# Cleaner, quieter and more economical

Reaction KLM Group in consultation  
Balanced Approach Schiphol

Royal Dutch Airlines

Juni 2023

### C.3 Increase in the ILS approach height

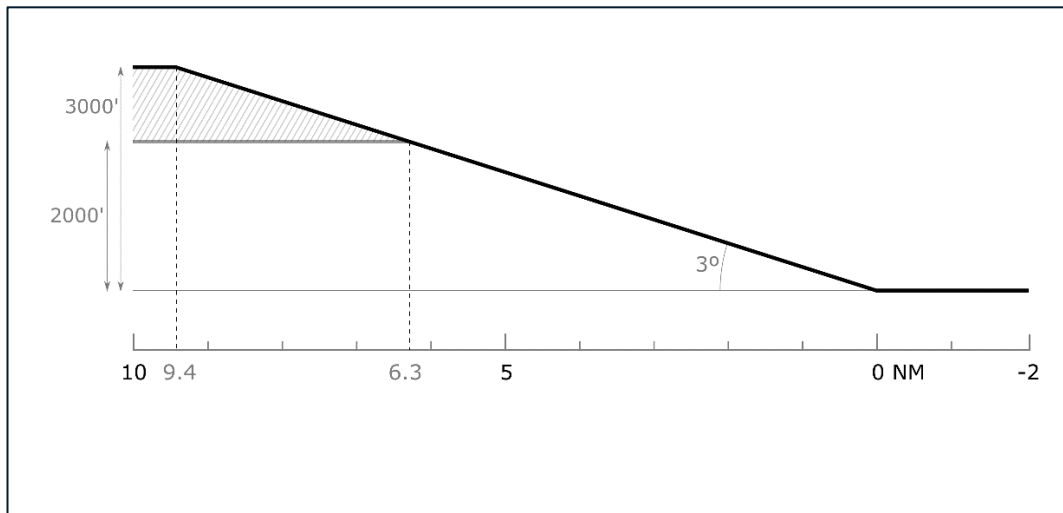
- (79) At present, the ILS approach height is set at 2000 feet and, in parallel approaches, at 2000 feet and 3000 feet respectively. Raising the ILS approach height will significantly reduce hindrance as the aircraft will continue to fly at higher altitudes for longer. To increase this height, LVNL will have to start an implementation procedure. This dependency has prevented this measure from being taken

into account. This measure will be very positive in terms of reducing hindrance and in terms of cost-effectiveness.

#### C.4 Change to S12 North departure procedures

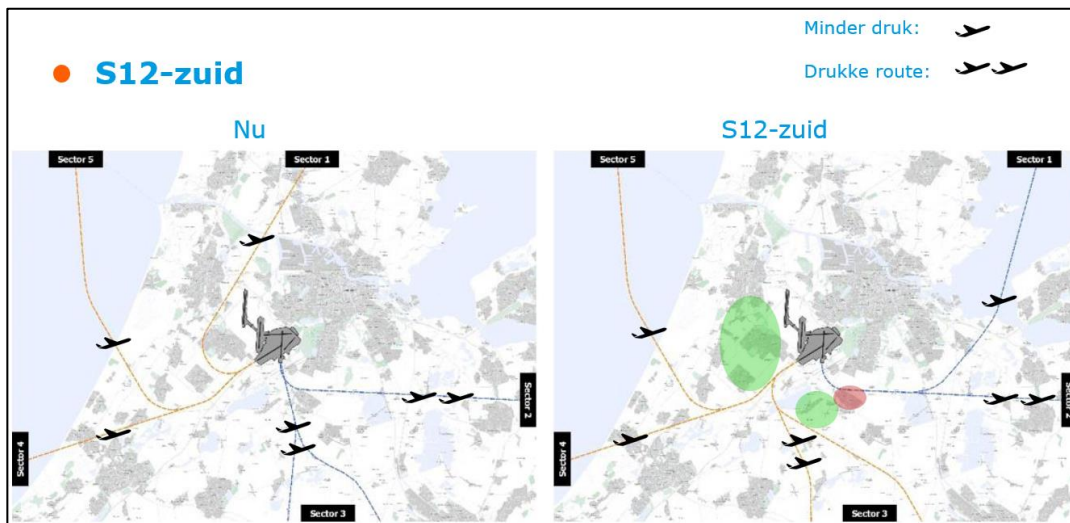
- (80) A lot of hindrance can be avoided, especially in the inland area, by allowing traffic to depart on other northern routes towards sectors 1 and 2. The figures below globally outline this change.
- (81) It is expected that this measure will lead to a significant reduction in hindrance.<sup>9</sup> A negative effect is a small increase in flight time, which means that this measure does have a slight impact on operational costs. To change the departure procedures, LVNL will have to start an implementation procedure. This dependency has prevented this measure from being taken into account. This measure will be very positive in terms of reducing hindrance and in terms of cost-effectiveness.

## C.6 Landing on runway 24 instead of 27 in the night

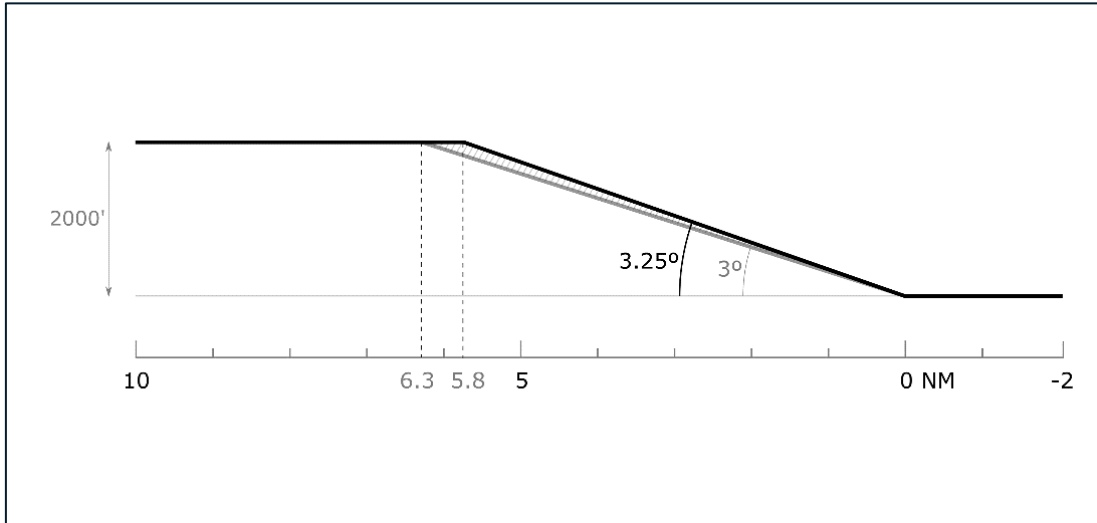
- (84) Significant reductions in hindrance can be achieved by having some aircraft touch down on runway 24 rather than runway 27 at night, especially when this is worked out on a seasonal basis. This is expected to have hardly any impact on operations or emissions, so this measure seems very cost-effective (cheaper for society). The LVB allows landing on runways 24 and 27 at night provided that none of the other runways is available or usable<sup>10</sup>; no order of preference is specified in this respect. This measure is in line with the NNHS. Runway 24 currently has an appropriate RNP arrival procedure. Runway 24 will be used in mixed mode and LVNL will have to start an implementation procedure for this. Due to the dependency on LVNL, this measure has not yet been taken into account in the analysis.

### C.8 RNP-AR: optimisation of arrival procedures

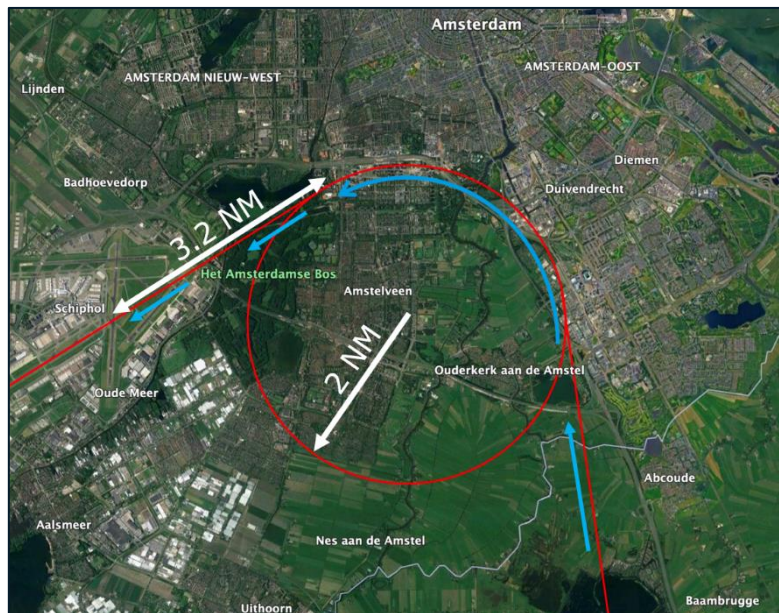
- (86) When applying arrival procedures by means of RNP-AR, various residential concentrations can be spared, which in turn can lead to a reduction in hindrance. An RNP-AR route is shown as an example in the figure below. A large proportion of aircraft must be fitted out with this equipment in order to apply this. At the moment, that number does not seem sufficient. However, in the longer term, this can be a very effective measure.

Figure 6 - Infographic of the Ministry

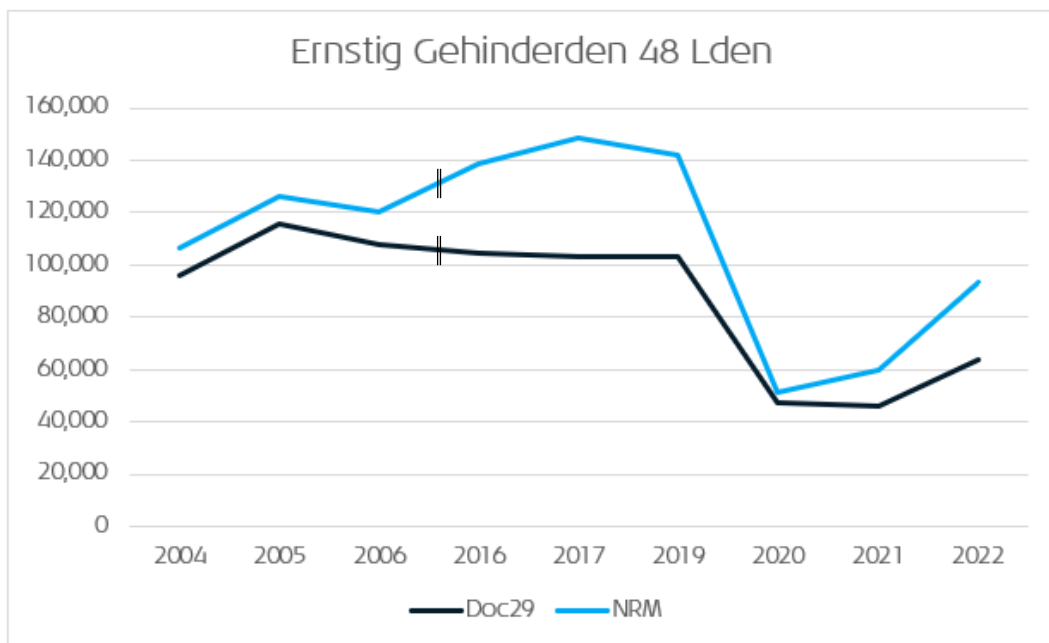
- (30) KLM Group is also surprised for other reasons that urgent action is said to be needed 'to bend the curve'. The Minister has used the Infographic to immediately show that intervention is needed:

- (31) This image seems to indicate that the noise level has risen dramatically in recent years and will rise significantly above the 'noise ceiling' in 2024 if action is not taken. This is unrealistic, as the number of flight movements will not exceed 500,000 in 2024, while there will also be fleet renewal (as the Ministry has also acknowledged when describing the autonomous developments). In addition, the Ministry has included graphs in the Consultation Paper about the actual trends in noise, which show that a downward trend had already started prior to the COVID-19 pandemic.<sup>38</sup> More important than this inconsistency in the Consultation documentation is that the downward trend can also be witnessed when the prescribed Doc 29 is used.<sup>39</sup>

## Beschouwing maatregelen lenW (2)

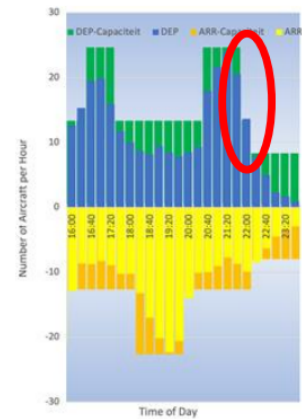
- Maatregel om het gebruik van stillere toestellen te stimuleren dmv luchthaventarieven (A2):
  - Hier worden alleen toestellen uit categorie S1 meegenomen

- Daardoor missen bijvoorbeeld de B737-800 en B737-900, terwijl types zijn die vervangen kunnen worden door de B737MAX of A320NEO
  - Ook andere types zoals B747-400, B757 en B777 worden niet meegenomen
